# Access Compliance Report

## Public Rights-of-Way

### (Pedestrian Signals)

Intersection ID: N/A	Main Street:	Cross Street: N/A	Location: N/A
ADA ID: E5CD2A03DC8D	Signal Type: One Push Button-APS	Overall Compliance: No	Severity Score: BTN 1: N/A BTN 2: N/A No BTN: N/A
Codes/Mitigation Info/Possible Solution		Field Measurements/Component Compliance

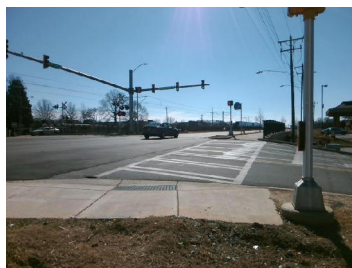
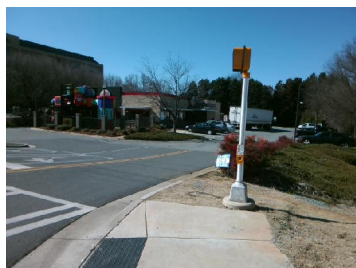
Possible Solutions: Remove & Replace  
Replace APS Button With New APS Button.  
Remove and Replace Clear Space.

PROW/ADA: R404.2, R404.3, R404.7.2,  
R209.1, MUTCD 4e.10
